Subject: Issuance of Amendment No. 30 to Facility Operating License NPF-10
and Amendment No. 19 to Facility Operating License NPF-15
San Onofre Nuclear Generating Station, Units 2 and 3

Amendment No. 30
License No. NPF-10

Amendment No. 19
License No. NPF-15

SAFETY EVALUATION

FIGURE 3.1 - 1A

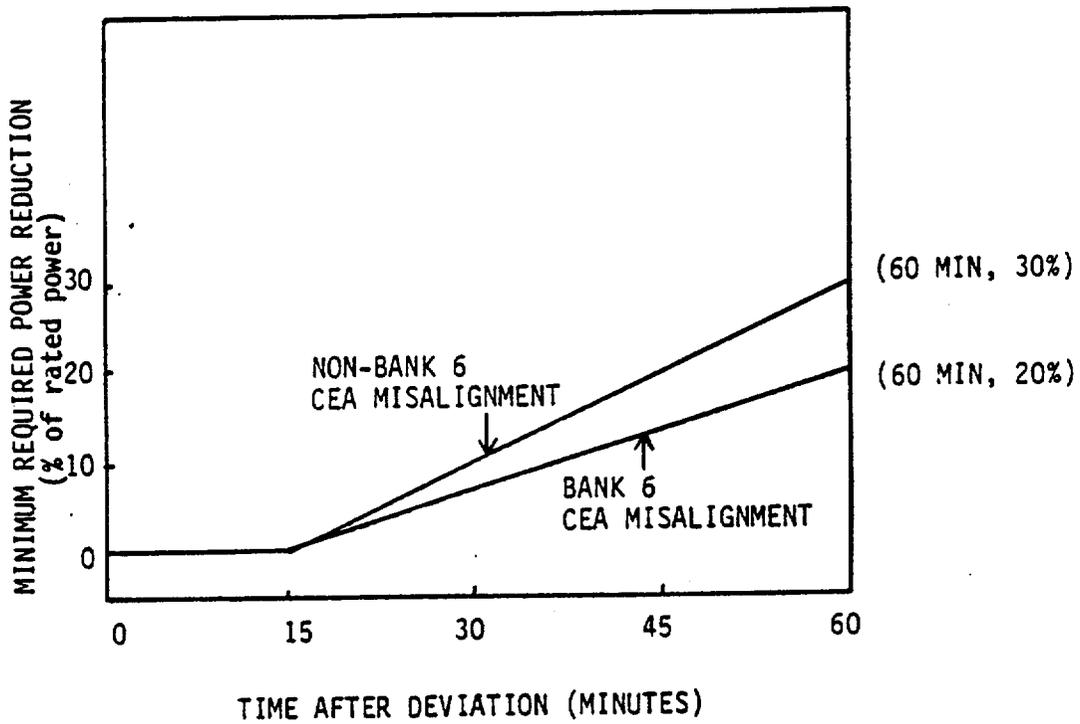
- c. With one full length or part length CEA misaligned from any other CEA in its group by more than 19 inches, operation in MODES 1 and 2 may continue, provided that core power is reduced in accordance with Figure 3.1-1A and that within one hour the misaligned CEA is either:

- d. With one or more full length or part length CEAs misaligned from any other CEAs in its group by more than 7 inches but less than or equal to 19 inches, operation in MODES 1 and 2 may continue, provided that core power is reduced in accordance with Figure 3.1-1A and that within one hour the misaligned CEA(s) is either:

- (a) Technical Specification 3.1.3.1, LCO for CEA position, is revised to include a new restriction that requires a core power reduction within 15 minutes after the detection of a CEA deviation;
- (b) Technical Specification 3.1.3.6, LCO for regulating CEA insertion limit, is revised to include a restriction that limits the regulating CEA group to the short term steady state insertion limit when the core operating limit supervisory system (COLSS) is out of service; and
- (c) Technical Specification 3.1.3.7, LCO for part length CEA insertion limit, is revised to impose a new insertion limit for the part length CEA group as shown in an added Figure 3.1-3.

In a plant with an analog protection system rather than a CPC, the single full length CEA drop is a design basis event which does not require a reactor trip. Rather, the required overpower margin (ROPM) is provided in the determination of limiting conditions for operation (LCO) to prevent the single CEA drop transient from violating the specified acceptable fuel design limits (SAFDL) of minimum DNBR and fuel melting. For a plant with CPCs, the CEA deviation PFs are applied to the CPC DNBR and LPD calculations to determine if the SAFDLs will be violated and, therefore, if a reactor trip is necessary to prevent the violation. The PFs consist of two components: a static component whose magnitude is dependent upon the CEA deviation configuration and magnitude, and a dynamic xenon component which is a linear function of time after CEA drop to account for the xenon redistribution effect. SCE has determined that the thermal margin maintained using COLSS operating limits is sufficient to accommodate the PF that is needed immediately after the CEA deviation. For some specific combinations of the initial CEA configuration and dropped CEA where the required PF exceeds the minimum ROPM maintained via COLSS, a power reduction is necessary to accommodate the residual PF. The magnitude of the power reduction as a function of time after CEA drop is specified in the new Figure 3.1-1A added to Technical Specification 3.1.3.1. This figure was determined from the worst PF (combination of the static and xenon components) that can occur for any specified CEA deviation from any initial CEA bank configuration to assure that the worst deviation while operating within the LCO space monitored by the COLSS will not cause a violation of the SAFDL. Since a power reduction in accordance with Figure 3.1-1A provides assurance that the SAFDLs are not exceeded subsequent to a CEA drop event, we conclude that the proposed change to Technical Specification 3.1.3.1 is acceptable.

* When core power is reduced to 60% of rated power per this limit curve, further reduction is not required by this specification.

Figure 3.1-2

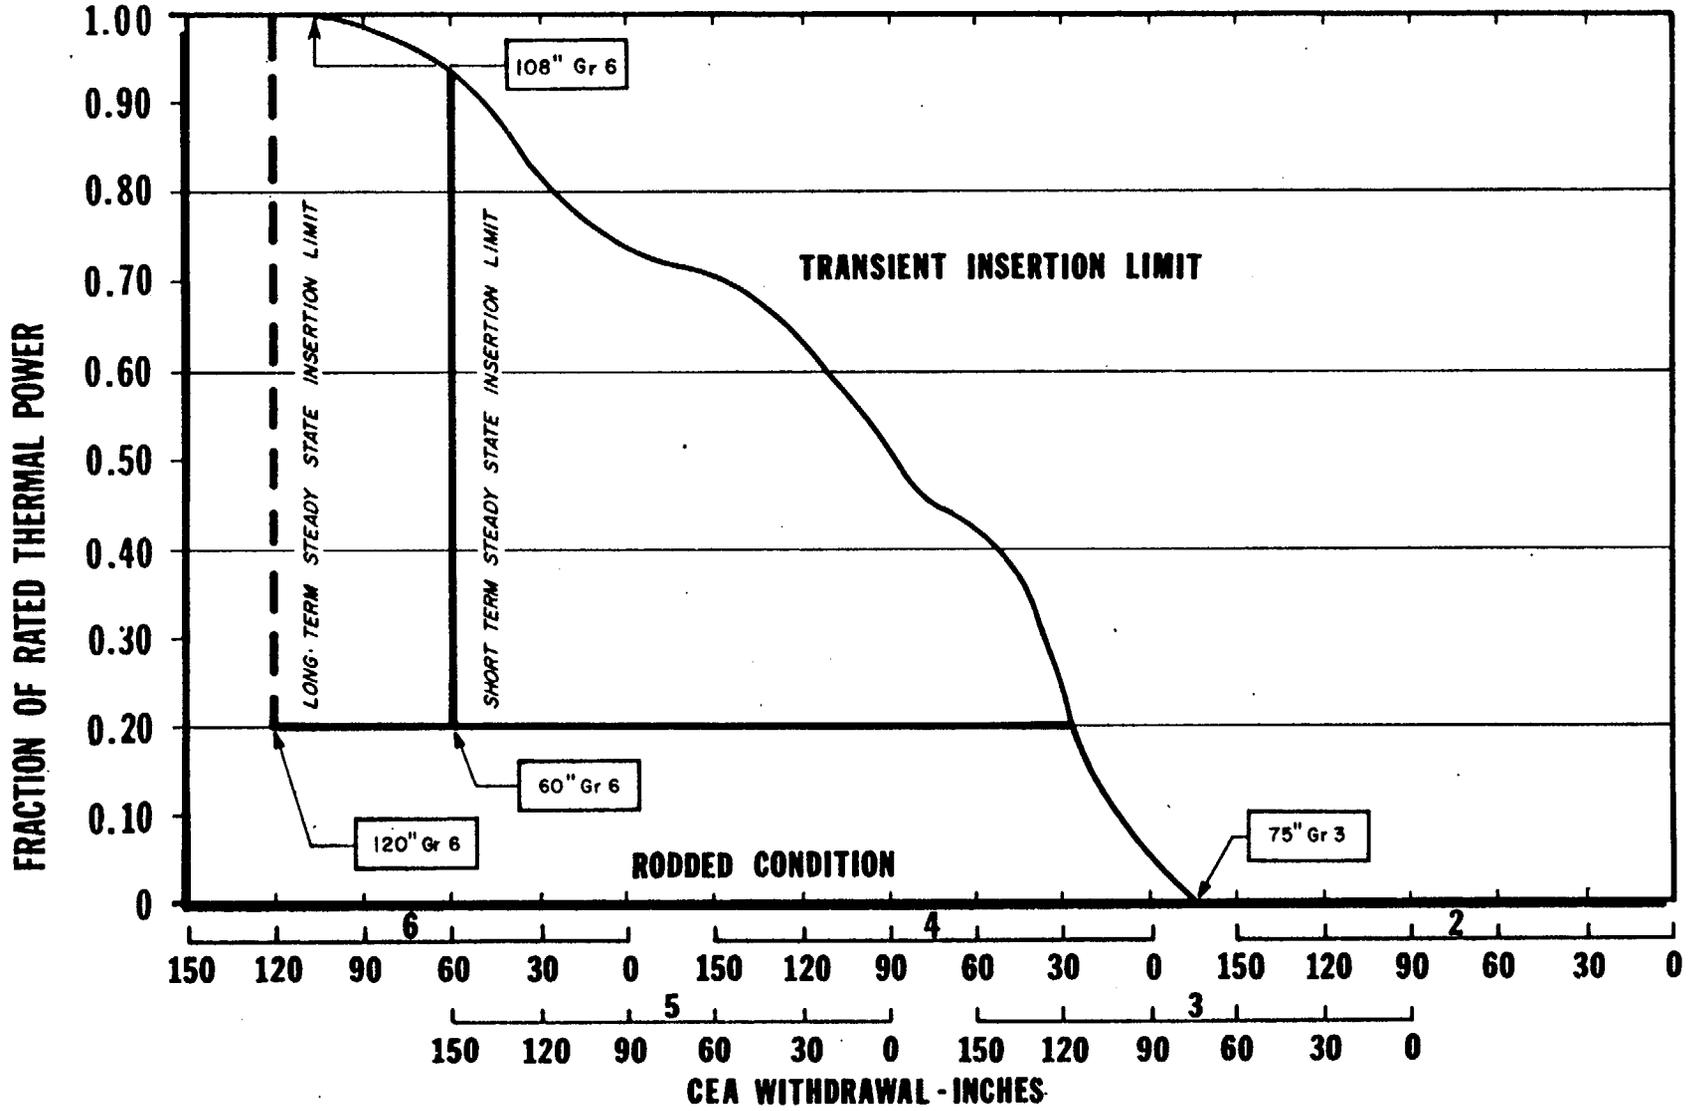
- a. When COLSS is in-service, the regulating CEA groups shall be limited to the withdrawal sequence and to the insertion limits shown on Figure 3.1-2. The CEA insertion between the Long Term Steady State Insertion Limits and the Transient Insertion Limits is restricted to:

3. Less than or equal to 14 Effective Full Power Days per calendar year.
- b. When COLSS is out-of-service, the regulating CEA groups shall be limited to the Short Term Steady State Insertion Limit shown on Figure 3.1-2. The CEA insertion between the Long Term Steady State Insertion Limits and the Short Term Steady State Insertion Limits is restricted to:

The existing Technical Specification 3.1.3.6 specifies that the regulating CEA groups shall be limited to the withdrawal sequence and insertion limits shown on Figure 3.1-2, with the CEA insertion between the long term steady state insertion limits and the transient insertion limits (TIL) restricted to a specified duration within a specified time interval. This specification

does not vary the CEA insertion limits whether the COLSS is in service or out of service. The proposed technical specification change will restrict the regulating CEA groups to the short term steady state insertion limit (STSSIL) when the COLSS is out of service. In other words, when the COLSS is out of service, CEA locations in the region between the STSSIL and TIL in Figure 3.1-2 are not permissible. Since the COLSS thermal margin includes a power dependent power operating limit (POL) bias to accommodate CEA drop and deviation from lower power CEA configurations, this POL bias must be compensated for when the COLSS is out of service. However, the limiting condition for operation of Technical Specifications 3.2.4 specifies the DNBR margin operating limit based on CPC calculation for COLSS out of service. This DNBR operating limit preserves the ROPM when COLSS is out of service. The proposed technical specification change imposes an additional power dependent insertion limit (PDIL) by restricting CEA motion to the short term insertion limit. SCE provided an analysis to show that the operating limit imposed in Technical Specification 3.2.4 and the proposed PDIL provide sufficient margin to compensate for the POL bias term and CEA deviation PFs when COLSS is out of service. On this basis we conclude that the addition of this restriction provides assurance that no SAFDL will be violated when COLSS is out of service and therefore we find this change to be acceptable.

Figure 3.1-3 PART 1 CEA INSERTION LIMIT vs. THERMAL POWER

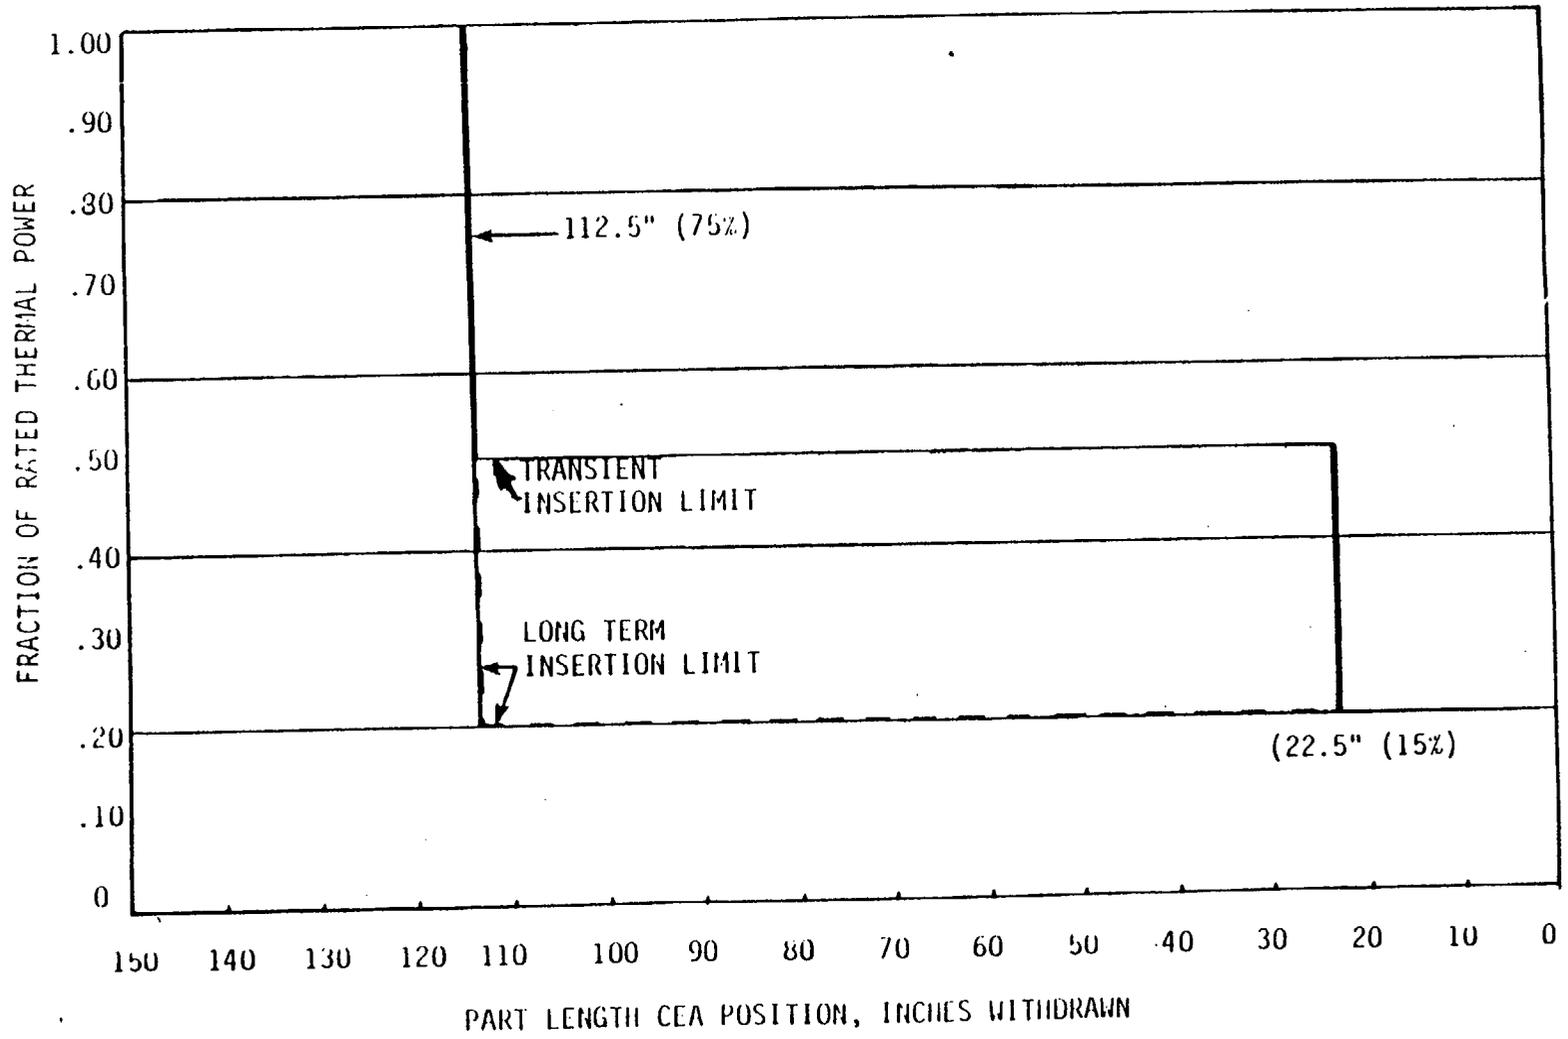
3.1.3.7 The position of the part length CEA group shall be restricted to prevent the neutron absorber section of the part length CEA group from covering the same axial segment of the fuel assemblies for a period in excess of 7 EFPD out of any 30 EFPD period. The position of the part length CEA group shall also be limited to the insertion limits shown on Figure 3.1-3.

The proposed change to Technical Specification 3.1.3.7 will restrict the part length CEA insertion to less than 25 percent for power levels greater than 50 percent of rated power as specified in the PDIL shown in the new Figure 3.1-3. The part length rods (PLR) are unique among the CEAs in that a PLR drop can cause a reactivity increase under the wrong set of circumstances. This reactivity increase will cause a temporary power excursion until the feedback mechanisms return the core to approximately its initial power. SCE has determined that the proposed restriction of PLR to less than 25 percent insertion will prevent a PLR drop from inserting positive reactivity for power levels above 50 percent of the rated power. For power levels below 50 percent, the long term insertion limit of 25 percent will still prevent a positive reactivity insertion on a PLR drop. However, operation between the long term and the transient insertion limits shown in Figure 3.1-3 could result in a

positive reactivity insertion on a PLR drop. The licensee provided an analysis to show that the ROPM available at those power levels is sufficient to accommodate a power increase from a PLR drop with positive reactivity insertion. We therefore conclude that the proposed change to Technical Specification 3.1.3.7 is acceptable.

FIGURE 3.1-1A

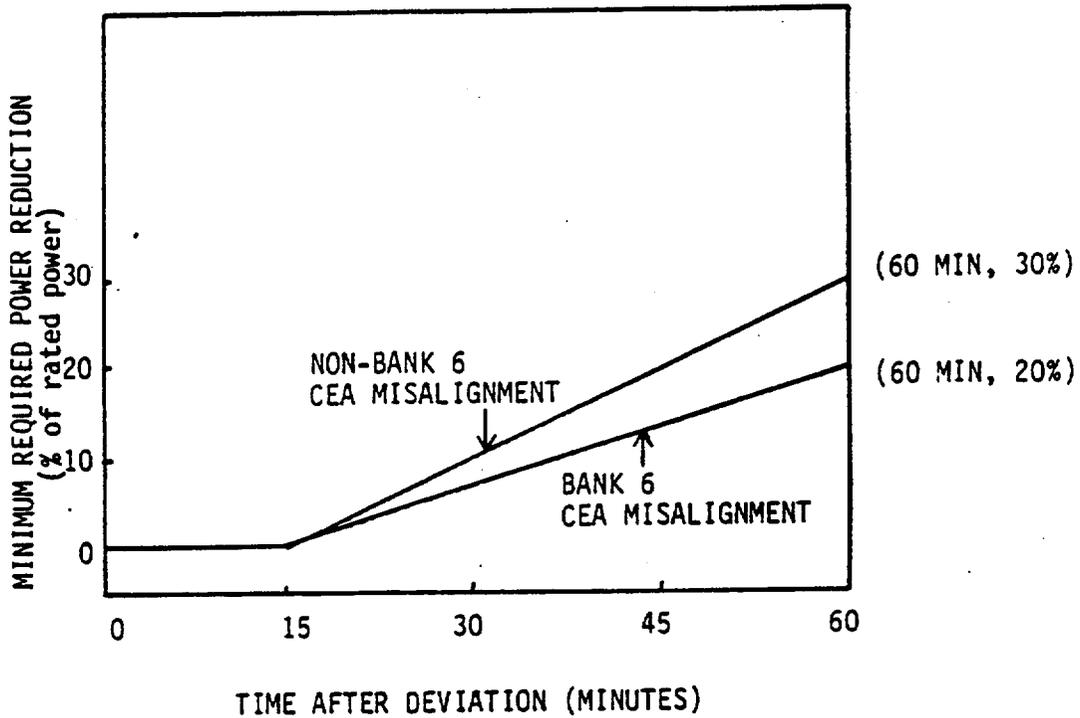
- c. With one full length or part length CEA misaligned from any other CEA in its group by more than 19 inches, operation in MODES 1 and 2 may continue, provided that core power is reduced in accordance with Figure 3.1-1A and that within one hour the misaligned CEA is either:

- d. With one or more full length or part length CEAs misaligned from any other CEAs in its group by more than 7 inches but less than or equal to 19 inches, operation in MODES 1 and 2 may continue, provided that core power is reduced in accordance with Figure 3.1-1A and that within one hour the misaligned CEA(s) is either:

* When core power is reduced to 60% of rated power per this limit curve, further reduction is not required by this specification.

Figure 3.1-2
CEA insertion limits vs fraction
of allowable thermal power

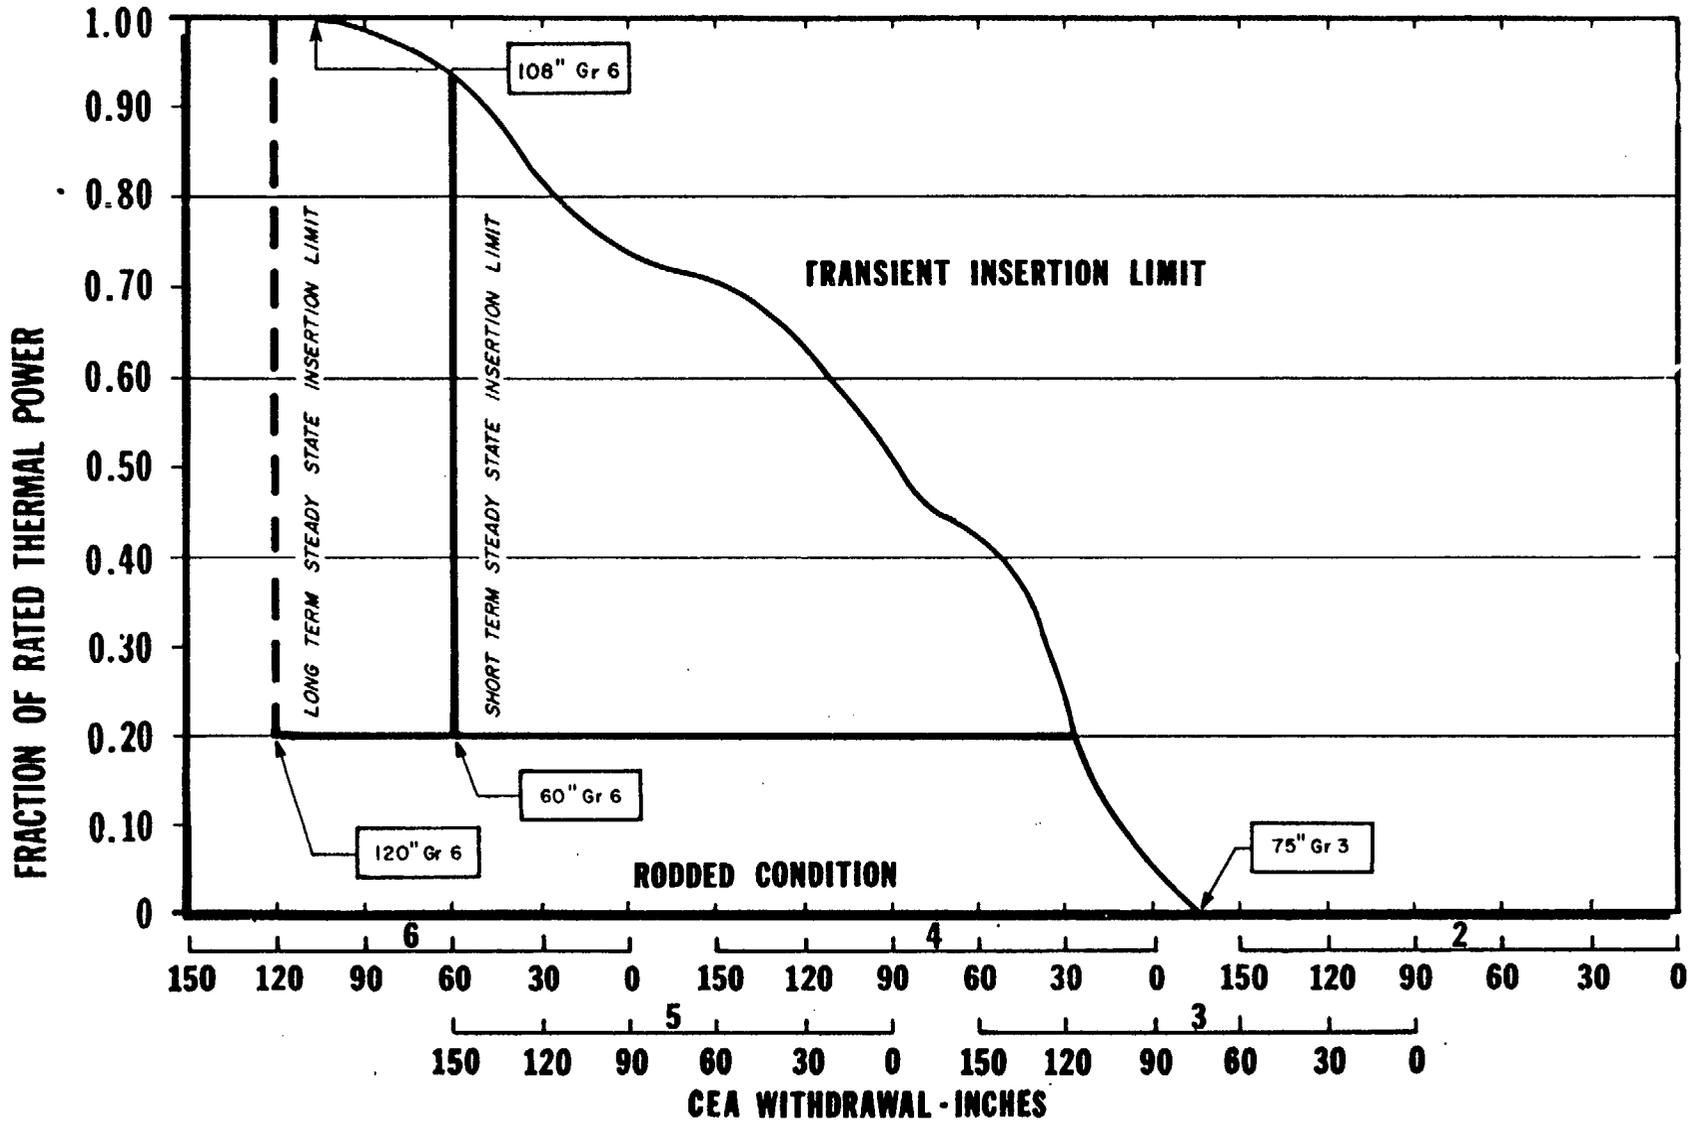
- a. When COLSS is in-service, the regulating CEA groups shall be limited to the withdrawal sequence and to the insertion limits shown on Figure 3.1-2. The CEA insertion between the Long Term Steady State Insertion Limits and the Transient Insertion Limits is restricted to:
 - 1. Less than or equal to 4 hours per 24 hour interval,
 - 2. Less than or equal to 5 Effective Full Power Days per 30 Effective Full Power Day interval, and
 - 3. Less than or equal to 14 Effective Full Power Days per calendar year.

- a. When COLSS is out-of-service, the regulating CEA groups shall be limited to the Short Term Steady State Insertion Limit shown on Figure 3.1-2. The CEA insertion between the Long Term Steady State Insertion Limits and the Short Term Steady State Insertion Limits is restricted to:
 - 1. Less than or equal to 4 hours per 24 hour interval,
 - 2. Less than or equal to 5 Effective Full Power Days per 30 Effective Full Power Day interval, and
 - 3. Less than or equal to 14 Effective Full Power Days per calendar year.
